Re: **Request #3 for Further Information – Kevler Development Ltd: RC225715/225716**

Kevler Development Ltd lodged subdivision and land use consents under the Operative Selwyn District Plan on 11 October 2022 for a 274 lot development on Springston-Rolleston Road, Rolleston. That application was lodged by Survus Consultants on behalf of the applicant. Subsequent to the Council's latest s92 requests Survus Consultants are no longer involved in this project.

**RE: Springston Rolleston Road Subdivision  
Further Response to Transport Related Information Requests**

## SITE PLAN

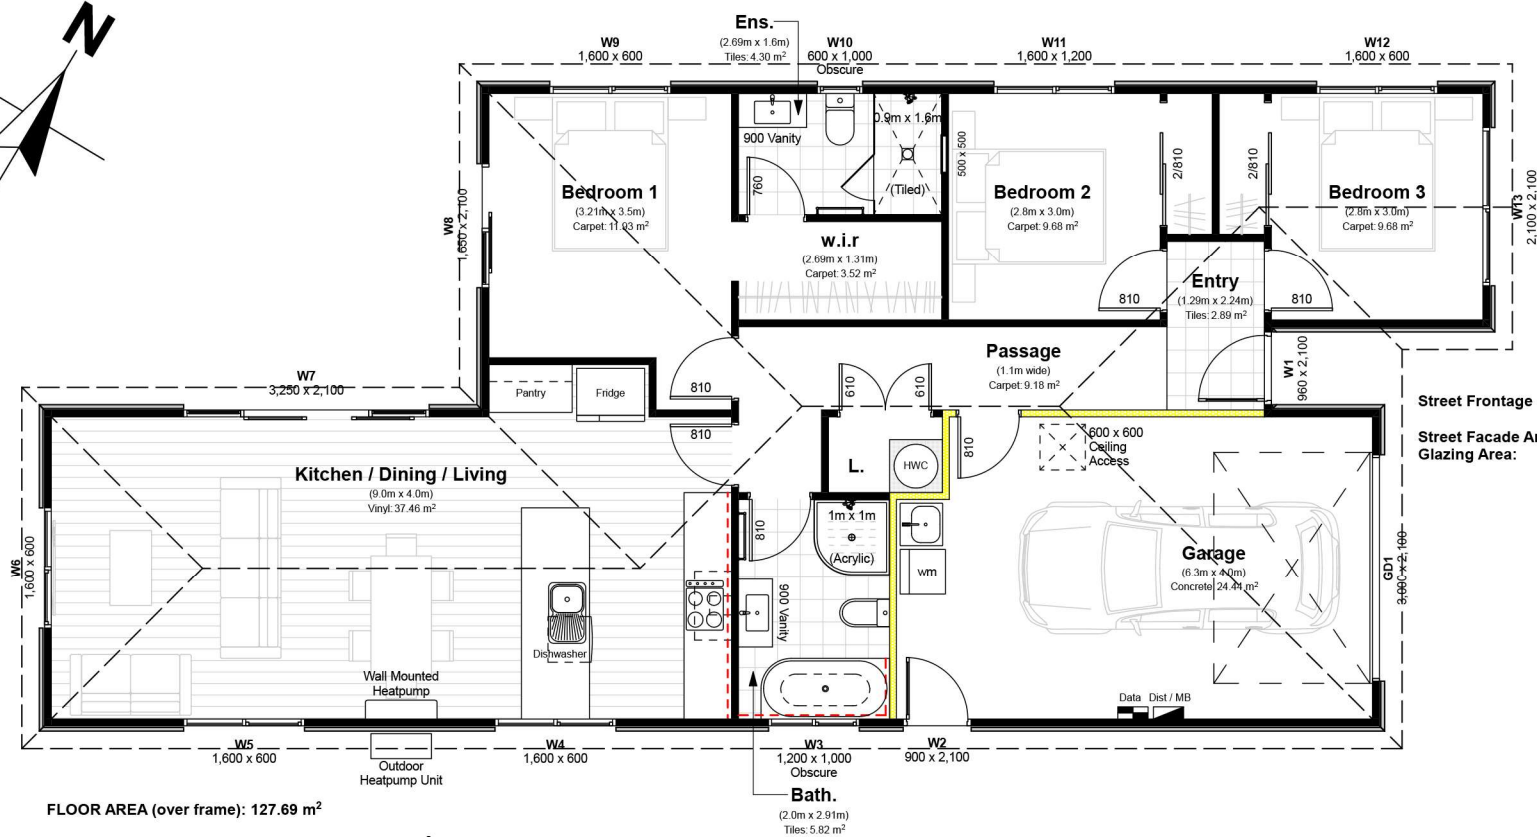
All lots facing Springston Rolleston Road have been checked and on-site turning is provided for so no vehicle is required to reverse on to or off a site. The plan for Lot 10 demonstrates this compliance **(Attachment C)**.

A. TYPICAL PLAN VIEW (1:100 @A3)

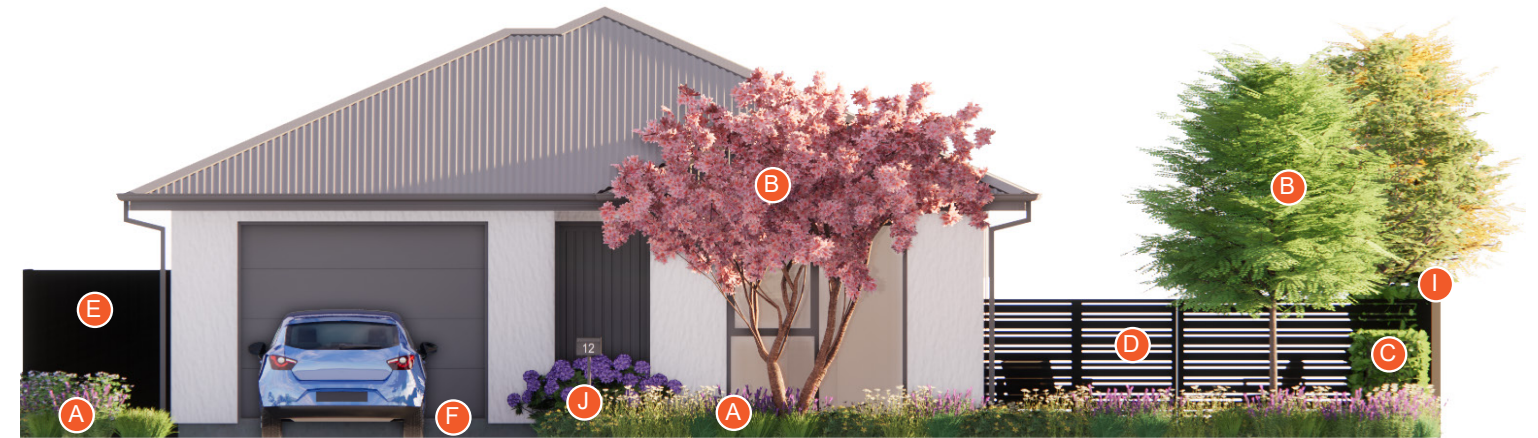
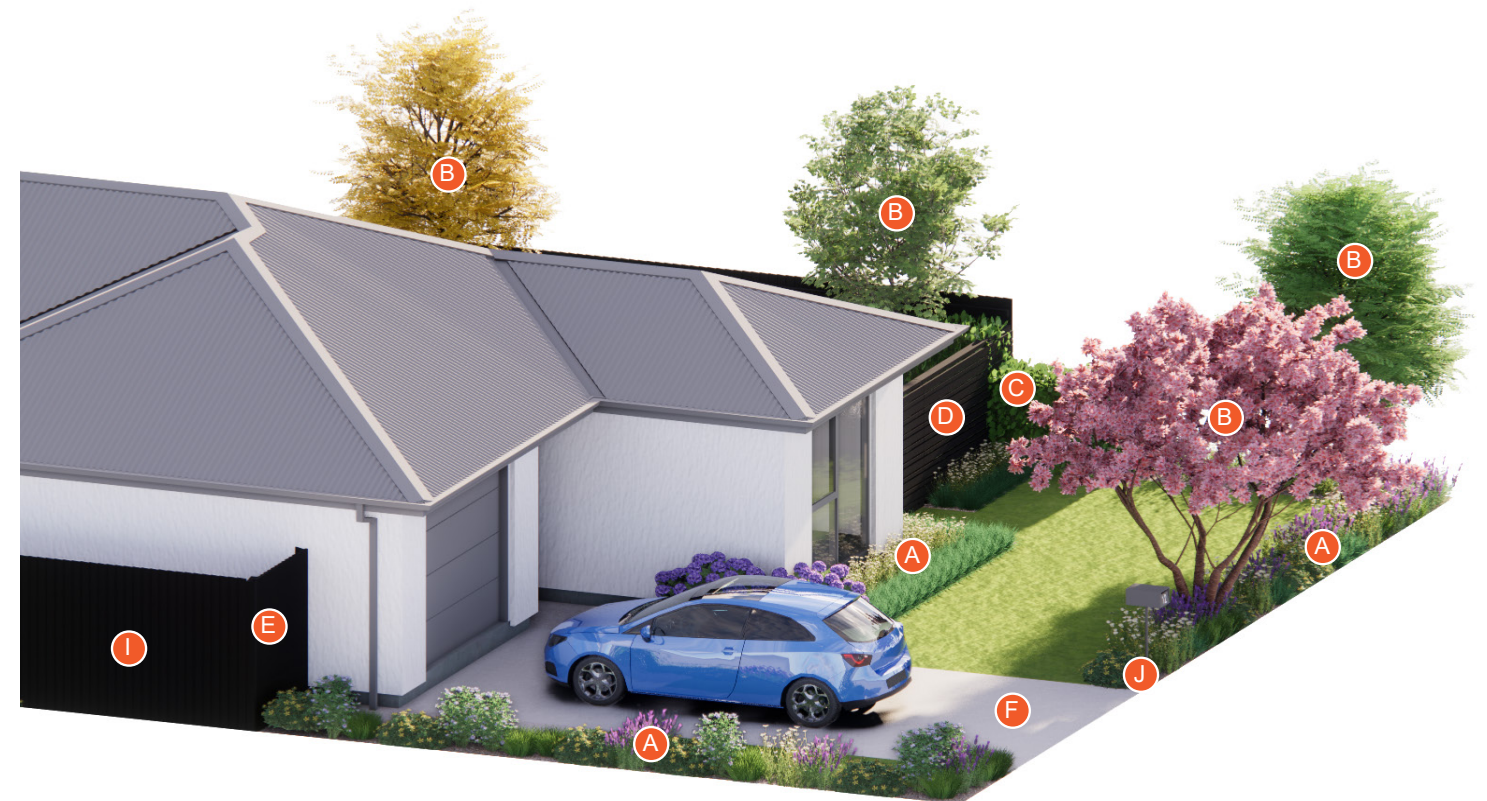
**Attachment D** is a visual representation of a typical lot concept design for a north facing lot demonstrating that the OLS/OS does not have to be in the front yard.

- Altered layout of lots 84-89.
- Demonstrated how OLS/OS can be accommodated in side yards especially for lots on the south side of internal roads. **Attachment D** is a visual demonstrates this approach for a lot of 327m<sup>2</sup>.
